Request for Class 2 Modification for Dangerous Waste Storage Permit WAD981769110

Removal of Minimum Btu Limit and Expansion of Glycol Storage Containment

RE: Emerald Recycling, Inc. Part B Permit Request for Class 2 Modification
Removal of Minimum Btu Limit and Expansion of Glycol Storage Containment

FACILITY LAYOUT DIAGRAM WITH GLYCOL EXPANSION AREA

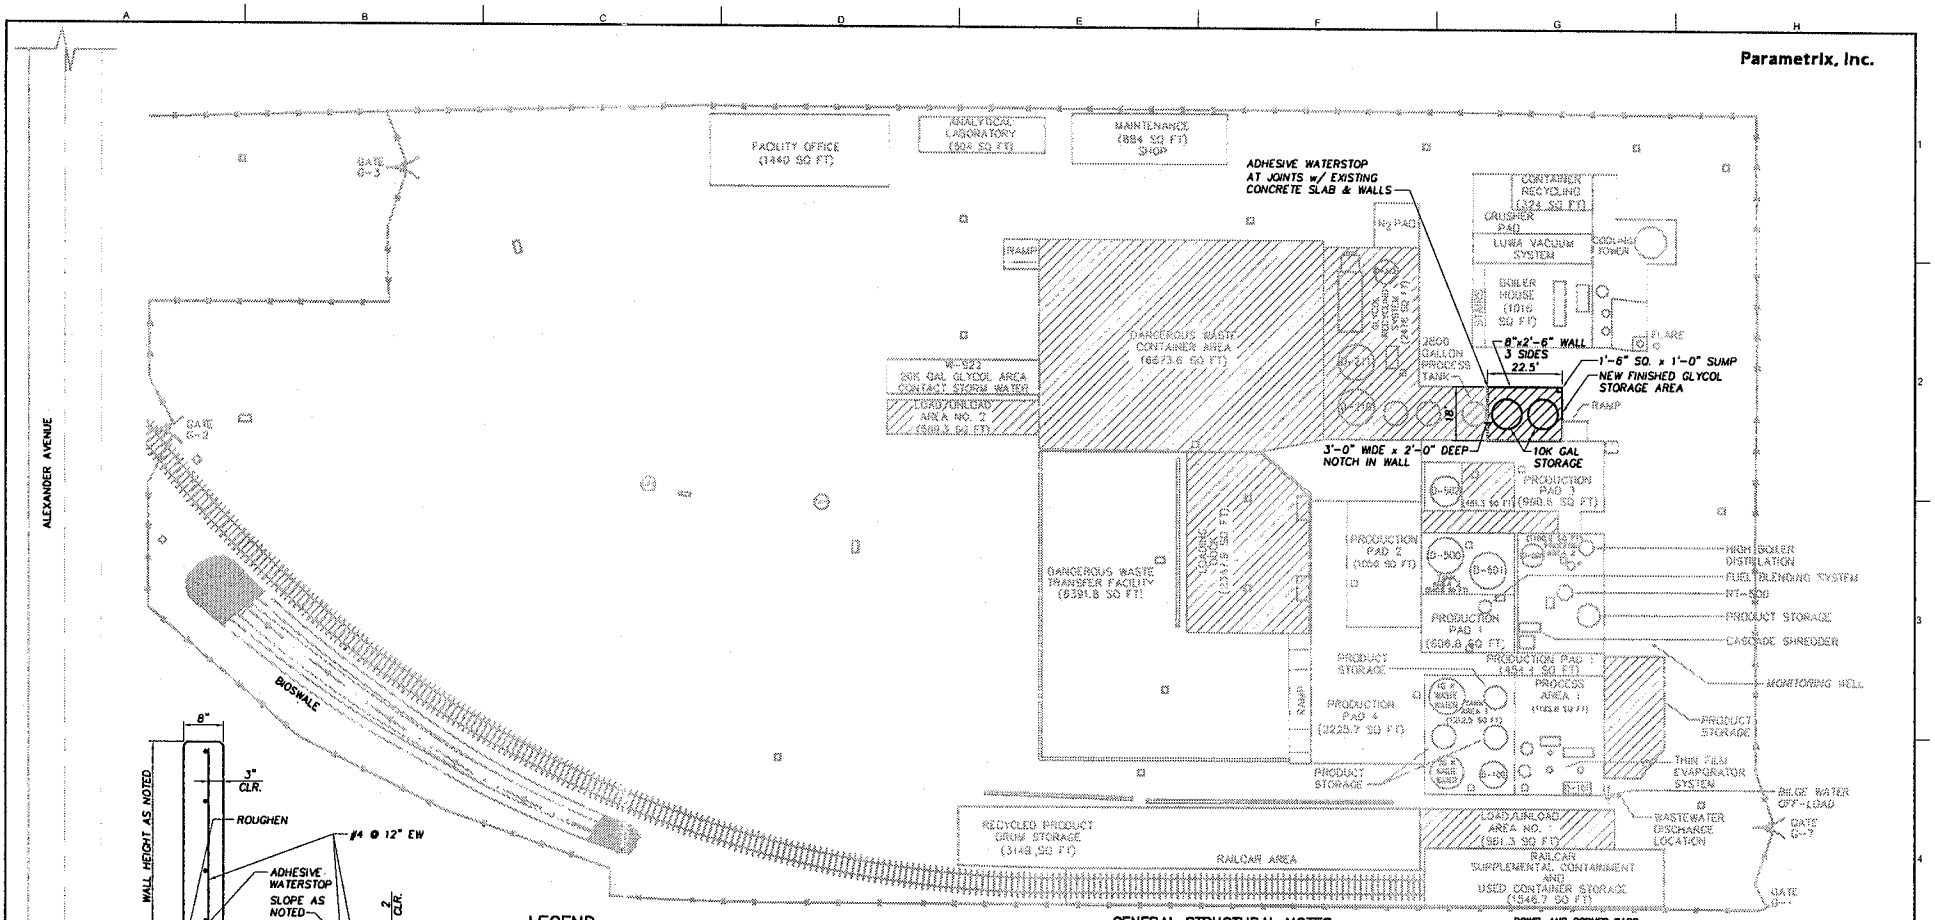
The new area would be an extension to the north of the existing area. The change to the existing area will consist of a notch in the north containment wall in order to connect the new containment area with the existing glycol storage containment. Engineer plans and specifications are included for review.
